MONTEREY PENINSULA WATER MANAGEMENT DISTRICT

**ADDENDUM NO. 2
TO
CONTRACT DOCUMENTS**

**For Construction
Of
BACKFLUSH BASIN EXPANSION PROJECT**

This Addendum (including attachments), dated September 6, 2018, includes 27 pages.

SCREENING WALL PROFILE AND DETAILS
MONTEREY PENINSULA WATER MANAGEMENT DISTRICT
SANTA MARGARITA ASR FACILITY SITE EXPANSION
1910 GENERAL JIM MOORE BOULEVARD

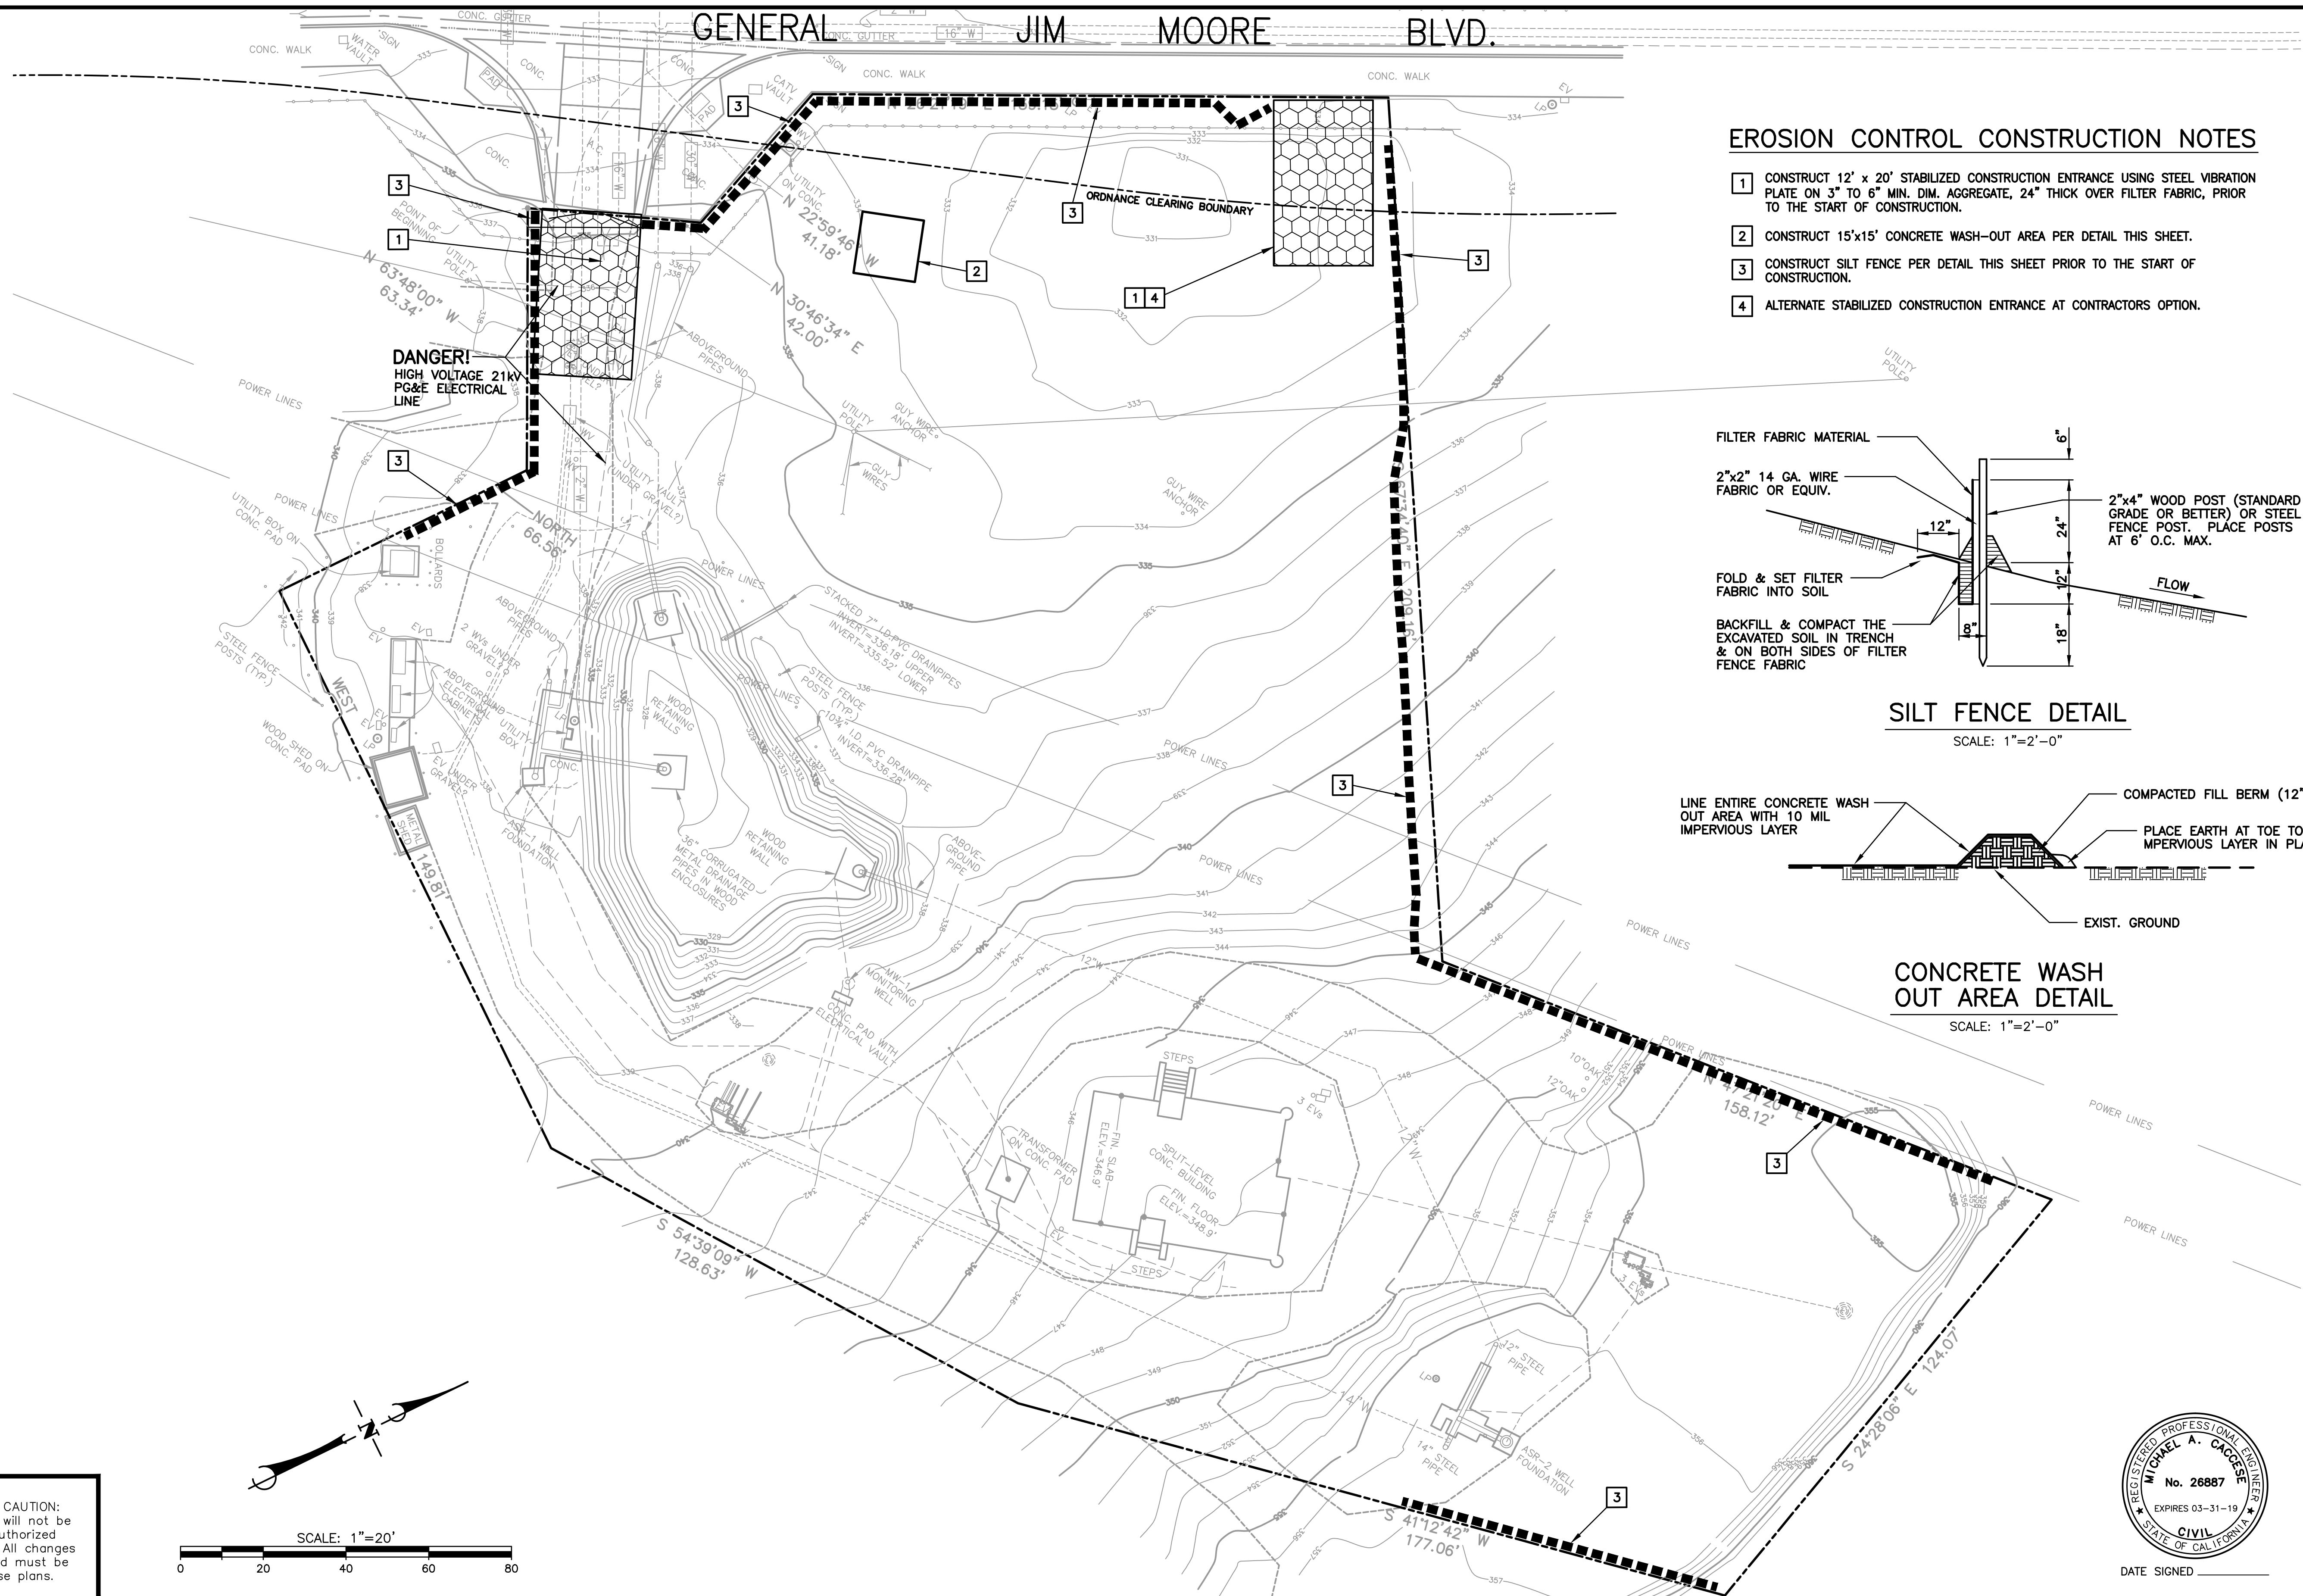
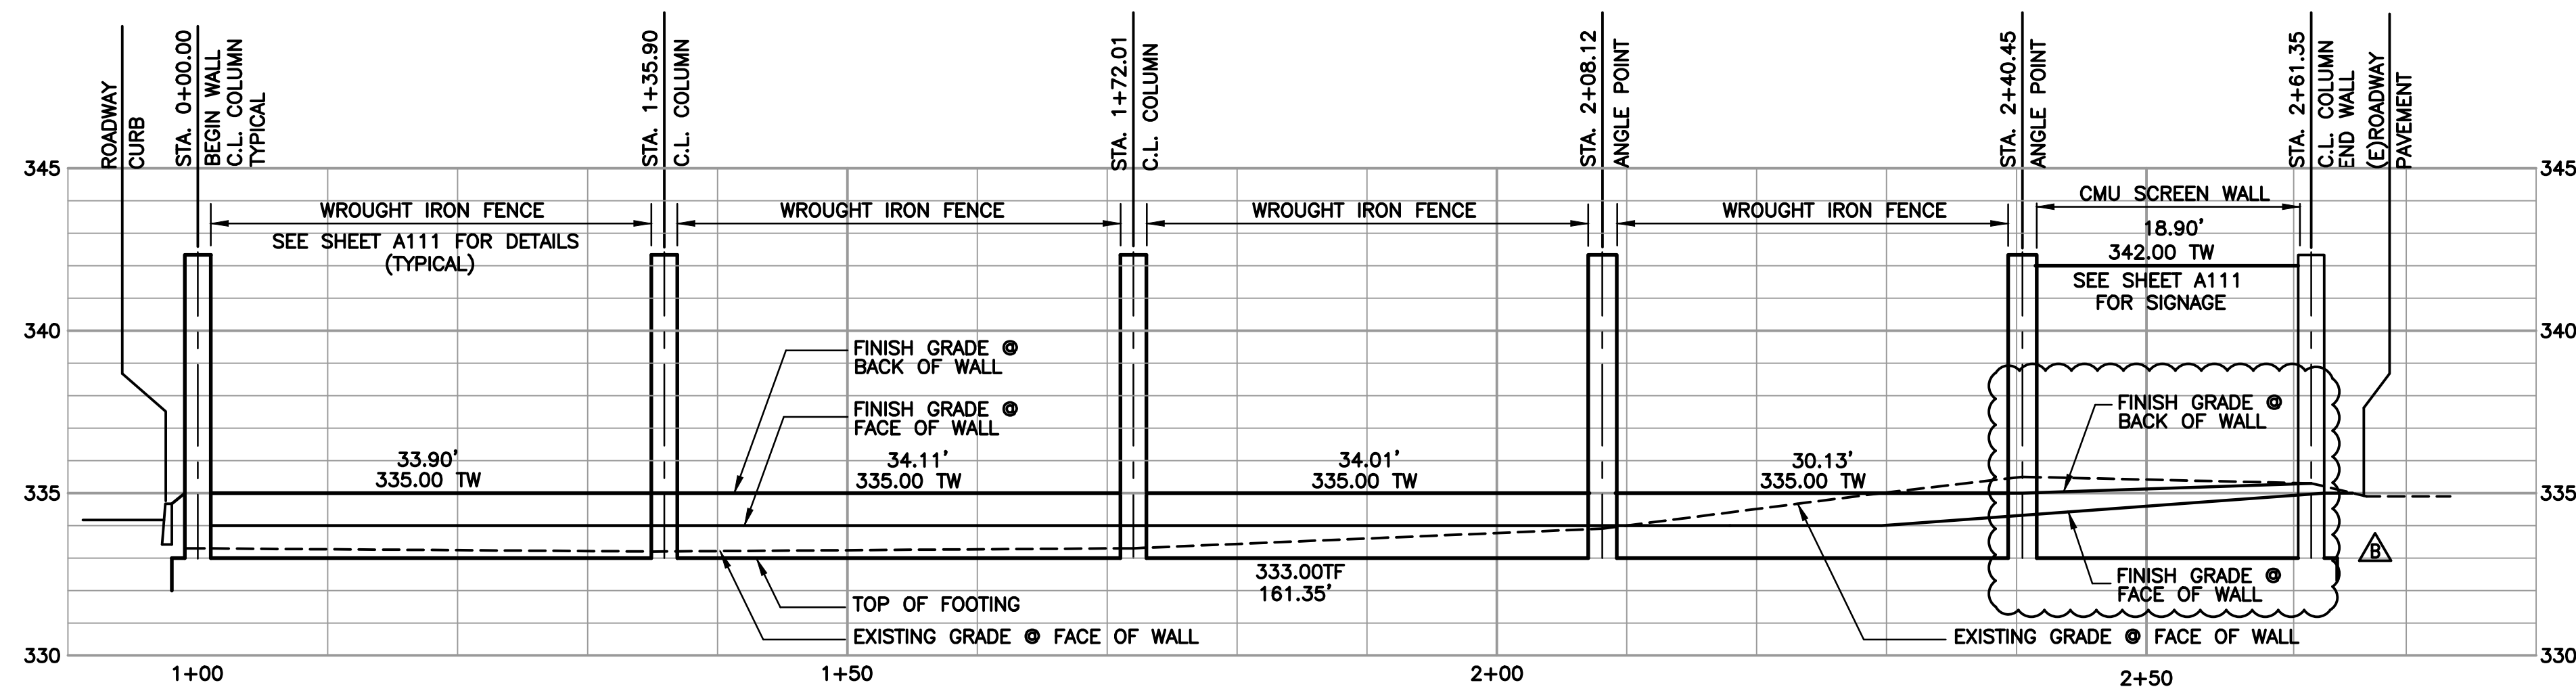
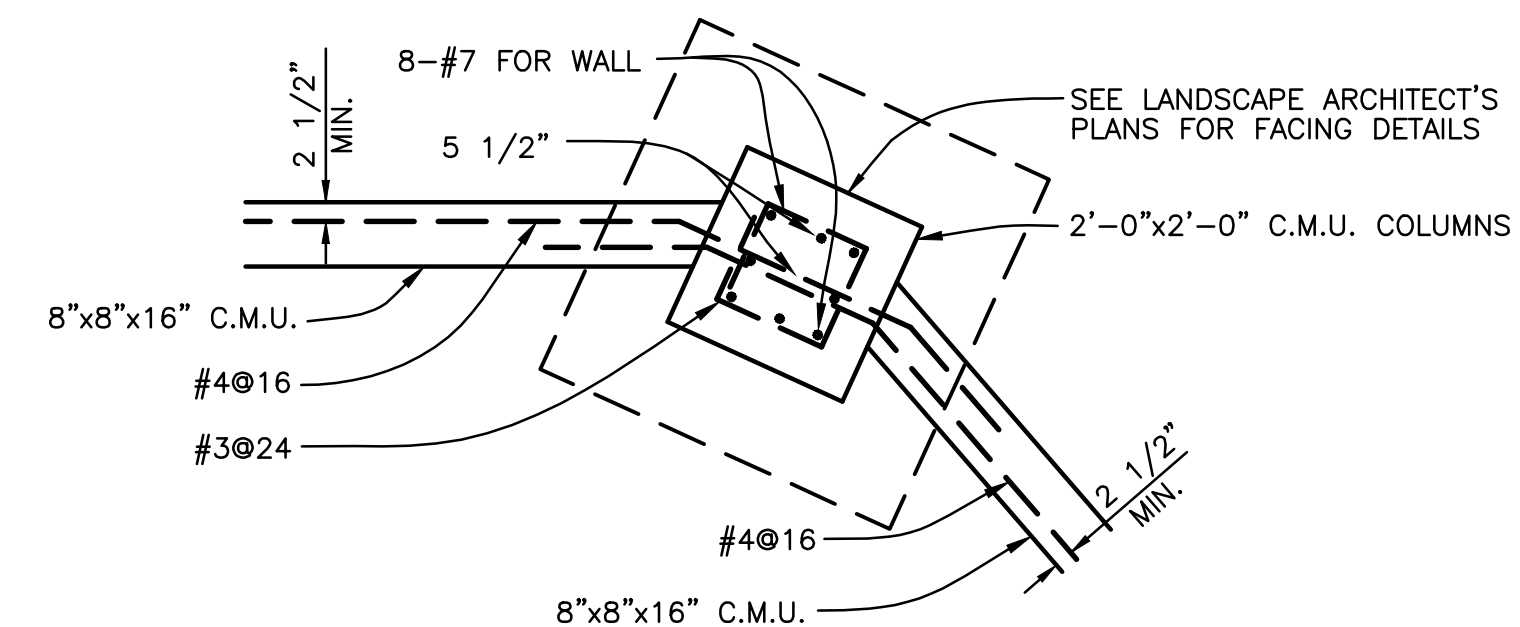
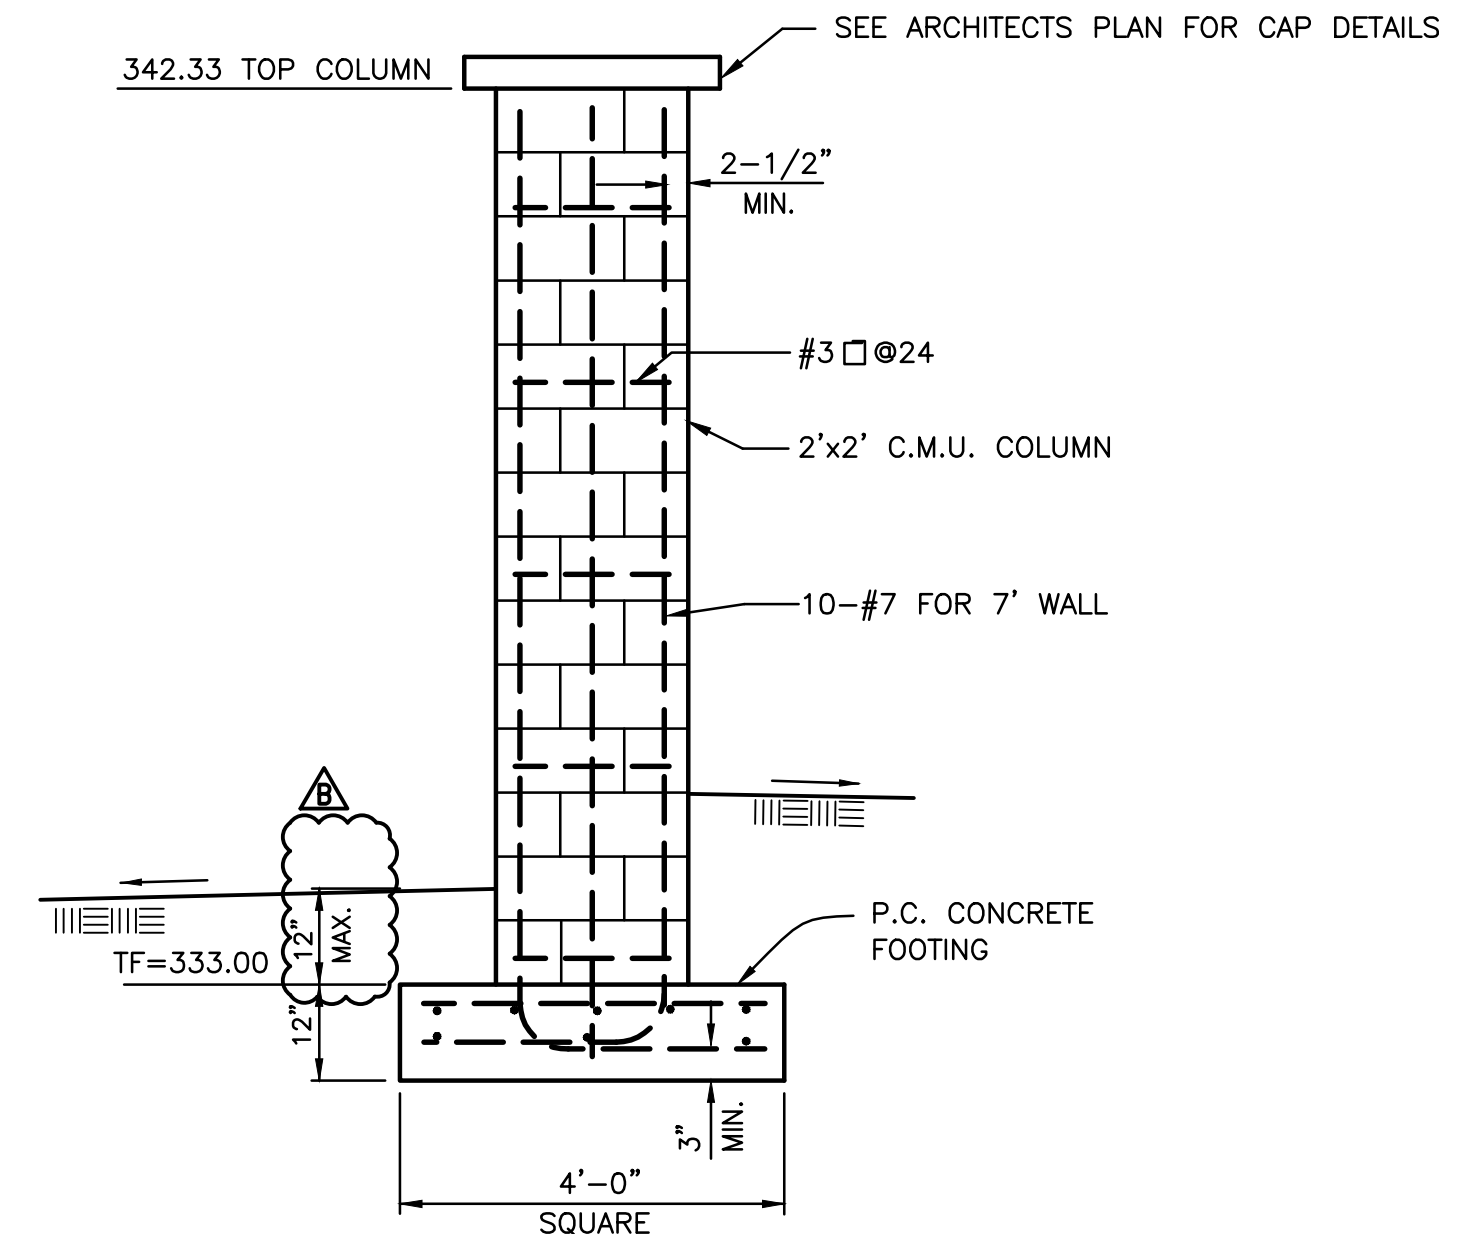
Plans on sheet 8 of 9 and Site Detail sheet do not indicate method of attachment of support posts for ornamental fence. Do the posts need to have plates welded to the post or do they need to be set in sleeves in the wall.

The fence posts are to have bolted anchorage to top of wall to allow future removal and reinstallation. Provide Ameristar custom welded base plate at each post, 4"x8" nominal base plate size with four (4) 5/8-inch diameter stainless steel wedge anchors with 2.5-inch minimum embedment.
